Sydney Metro Martin Place

Over Station Development

Design Review Panel #08

25 February 2019

Elements along Hunter Street edge

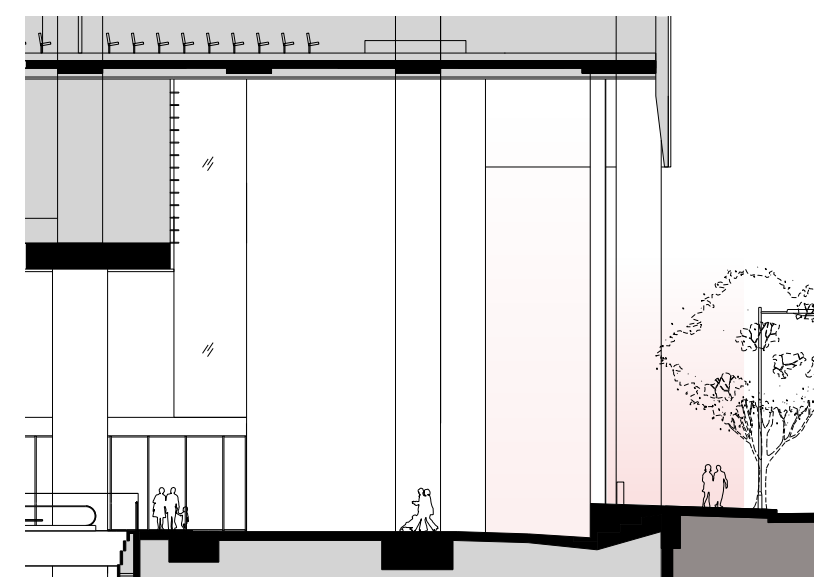
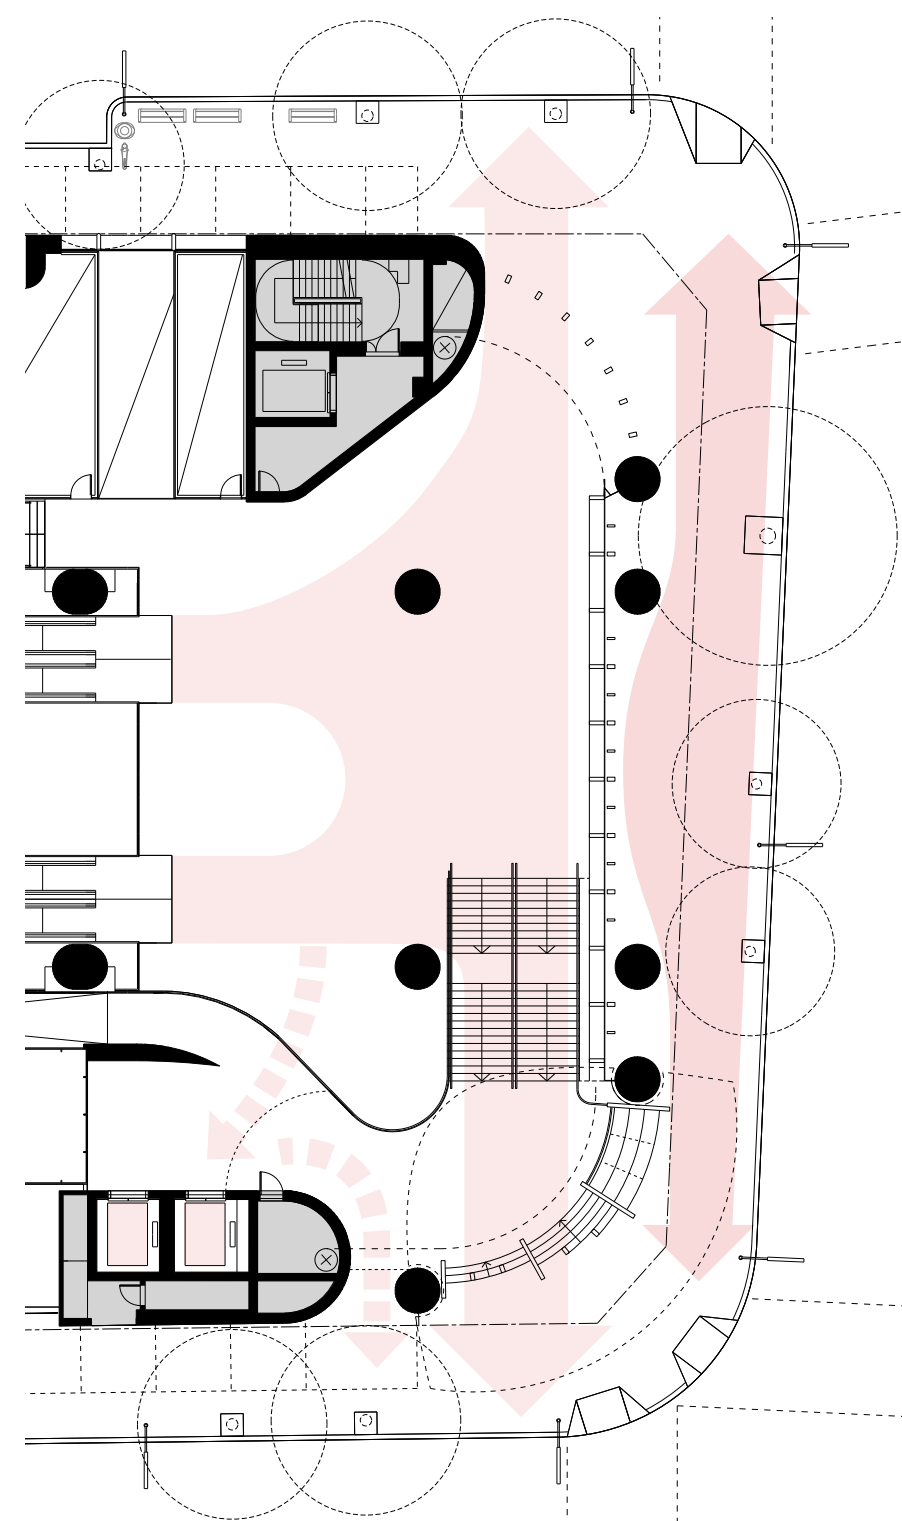
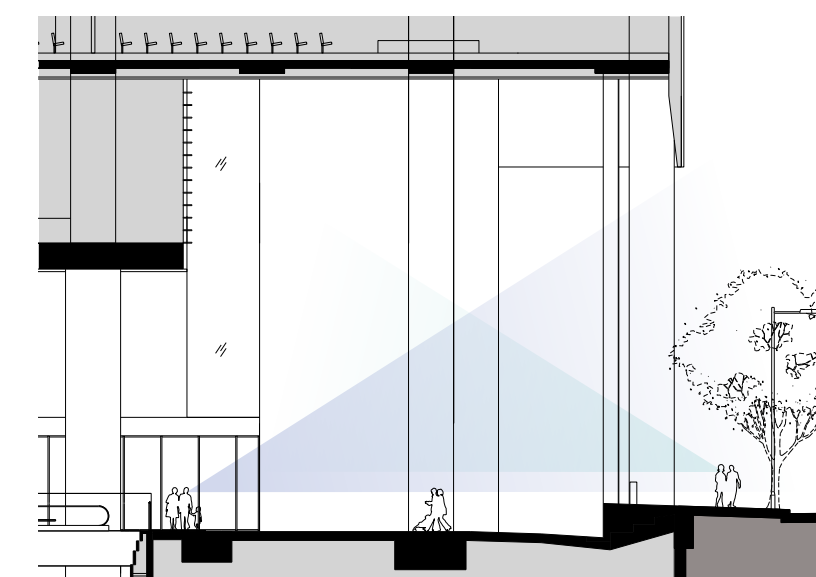
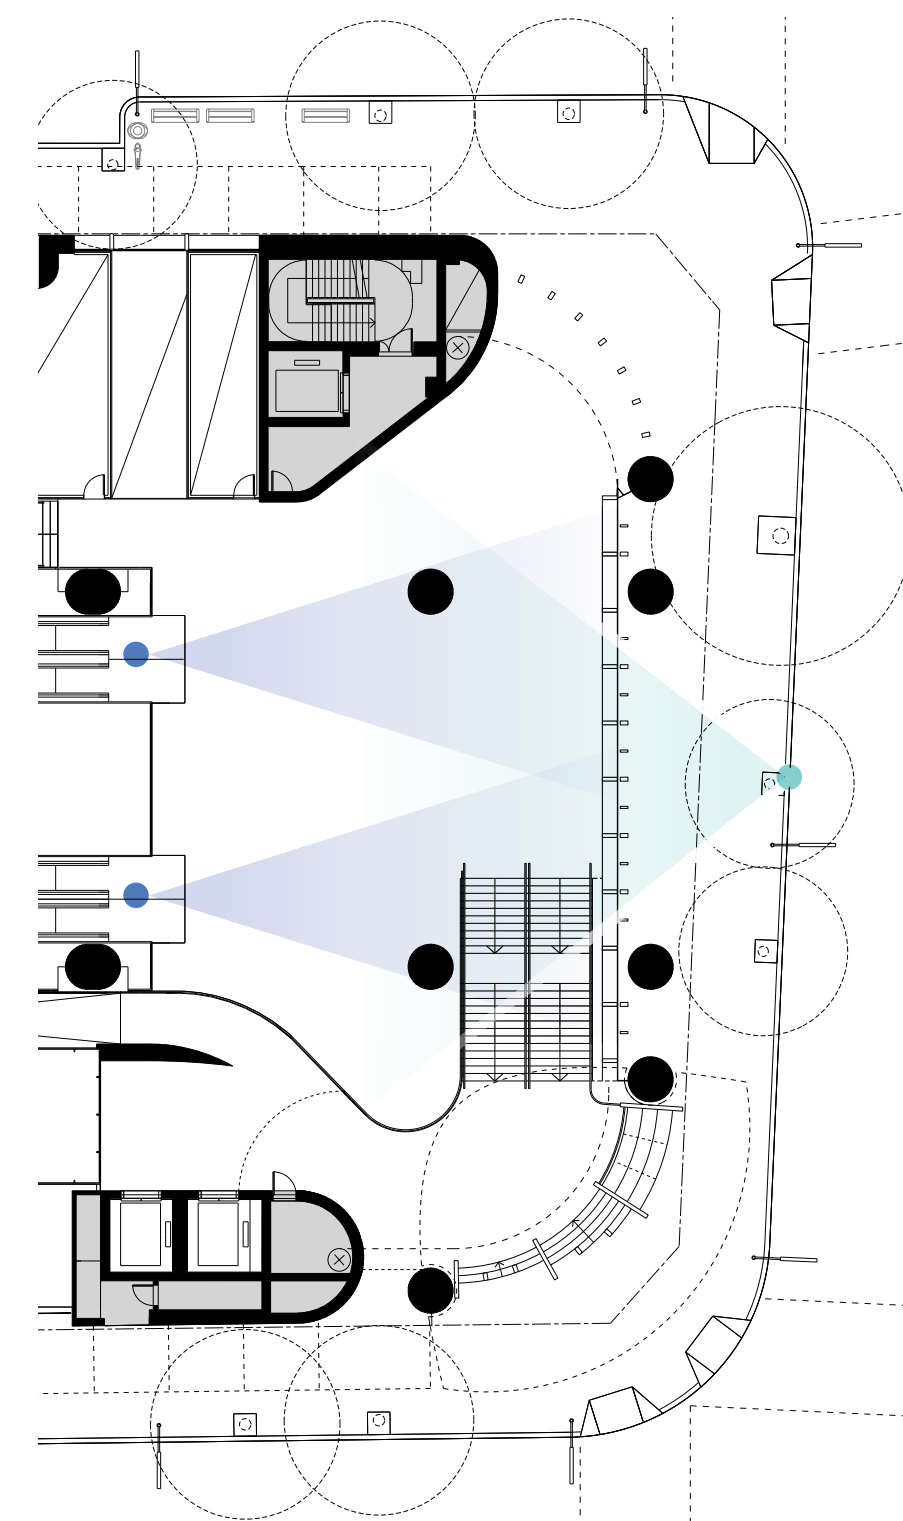
OSD DRP comment:

*“While the proposal for stairs creates a more welcoming corner entrance, the building’s interface with Hunter Street is unresolved. We are **concerned about the spaces between the building and columns** on the northern elevation.”*

*“We recommend consideration of **opportunities for public seating** between the columns on the northern elevation to Hunter Street.”*

Station DRP comment:

“The areas between the columns and footpath to Hunter are not optimised and lack a positive civic presence.”

Current proposal — No seating

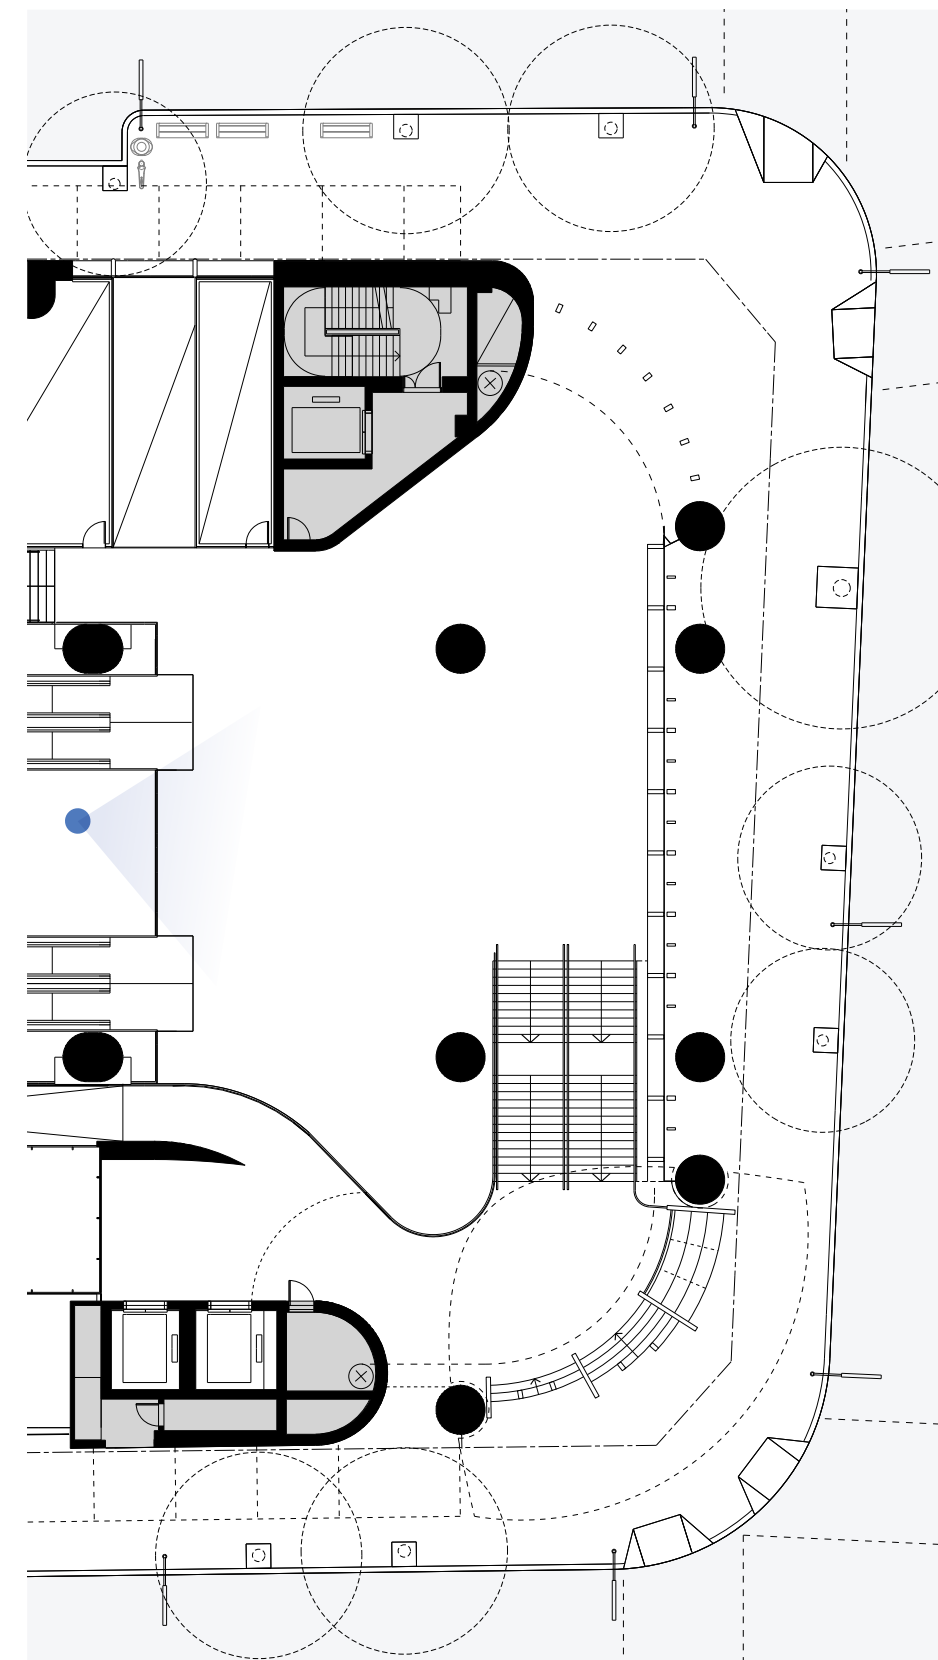
OSD DRP comment:

*“While the proposal for stairs creates a more welcoming corner entrance, the building’s interface with Hunter Street is unresolved. We are **concerned about the spaces between the building and columns** on the northern elevation.”*

*“We recommend consideration of **opportunities for public seating** between the columns on the northern elevation to Hunter Street.”*

Station DRP comment:

“The areas between the columns and footpath to Hunter are not optimised and lack a positive civic presence.”

Seating study

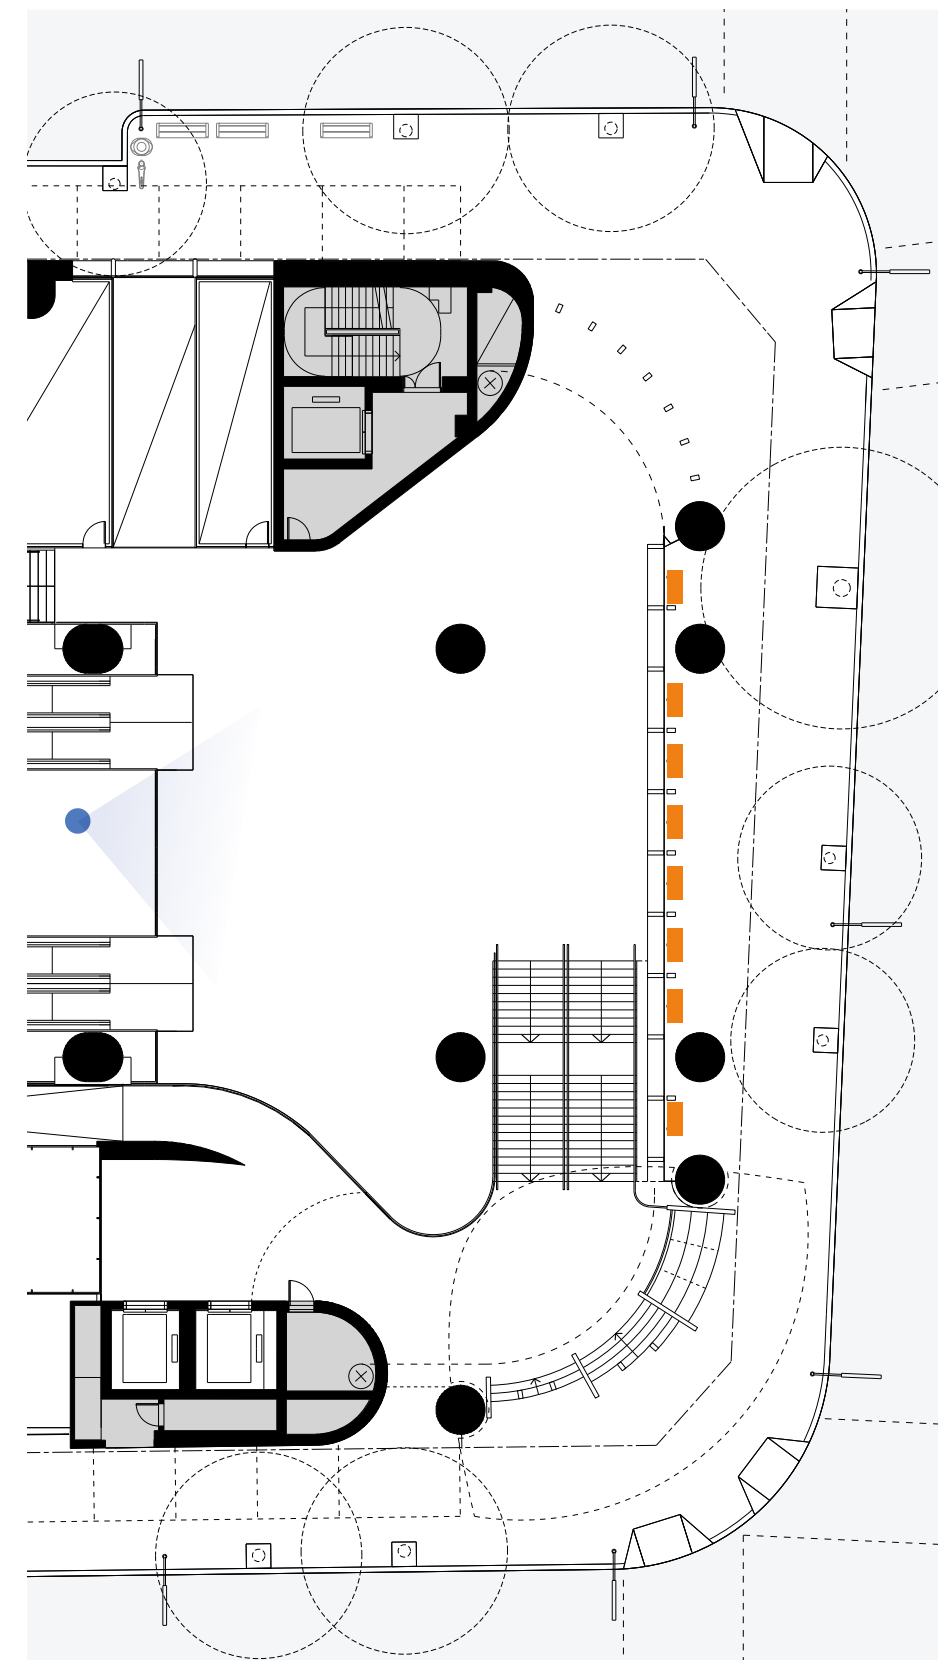
OSD DRP comment:

*“While the proposal for stairs creates a more welcoming corner entrance, the building’s interface with Hunter Street is unresolved. We are **concerned about the spaces between the building and columns** on the northern elevation.”*

*“We recommend consideration of **opportunities for public seating** between the columns on the northern elevation to Hunter Street.”*

Station DRP comment:

“The areas between the columns and footpath to Hunter are not optimised and lack a positive civic presence.”

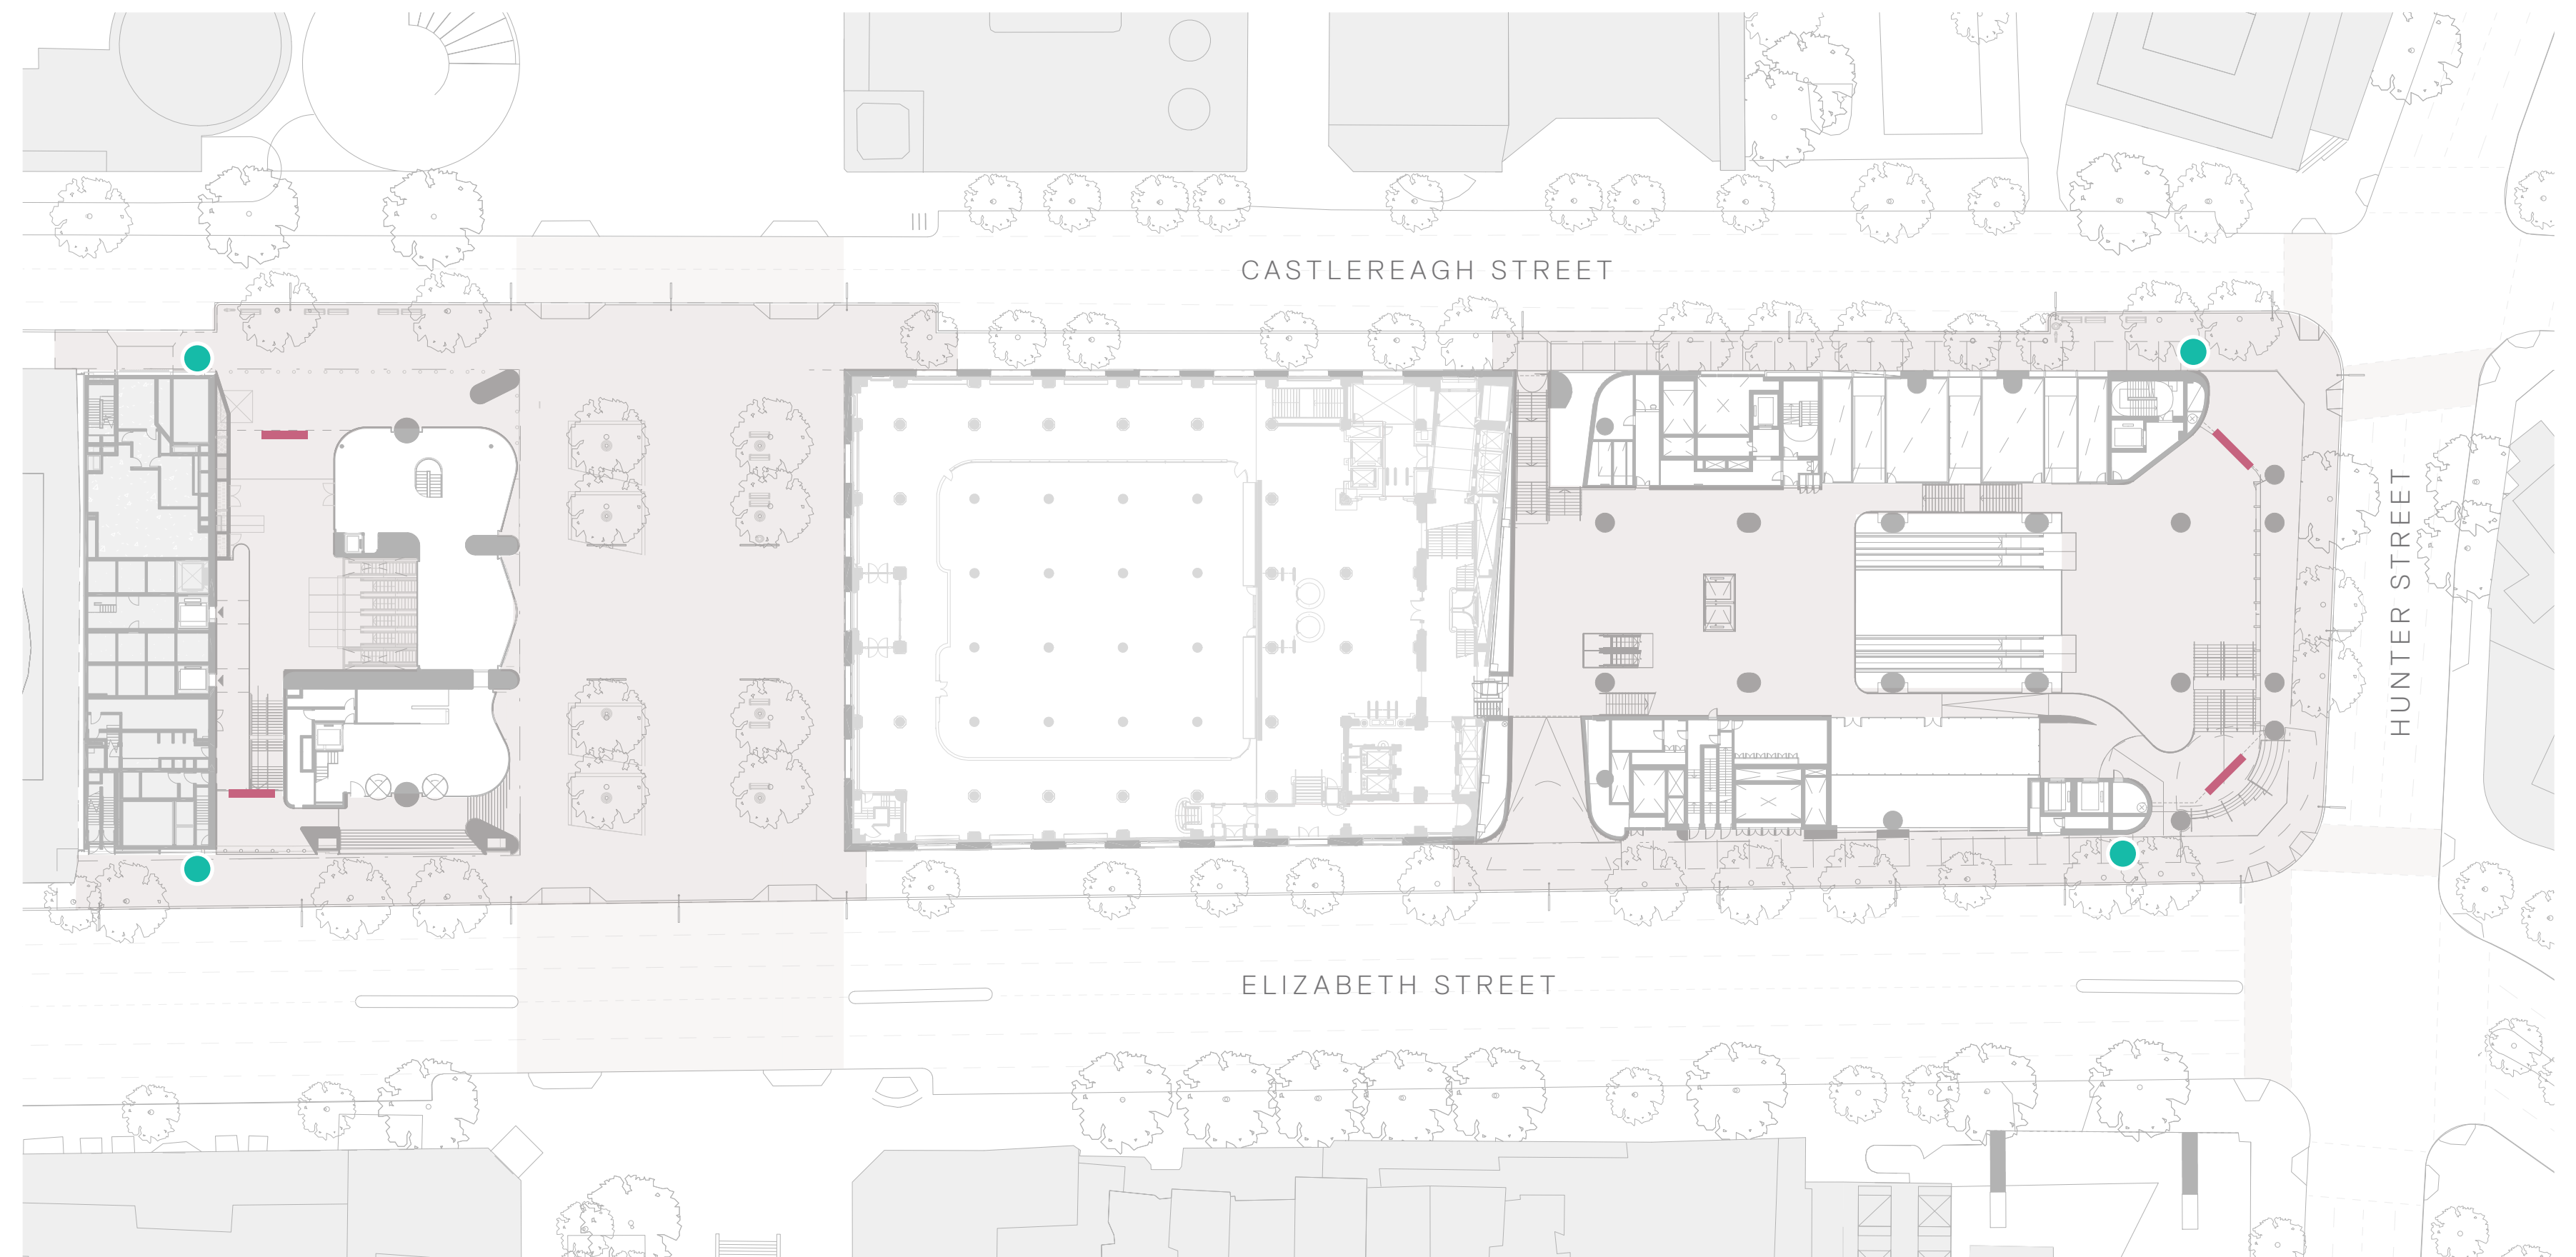
OSD DRP comment:

“While we support the awning proposal, we recommend it be lowered as far as possible to improve weather protection, particularly that portion of the awning which is raised to mark the entrance to the through site link.”

*“Further design refinement is required to **ensure the awnings which mark entrances to public and private spaces are differentiated.**”*

Station DRP comment:

*“The Panel encourages further review of the awning at the entry to the mid-block connection to **ensure that the station entry has an appropriate clarity and identity.**”*

*“Further design review of the awning above the entry to the mid-block connection on Elizabeth and Castlereagh Streets to ensure the awnings serve their intended purpose of weather protection and **give the station entry sufficient clarity / visual identity.**”*
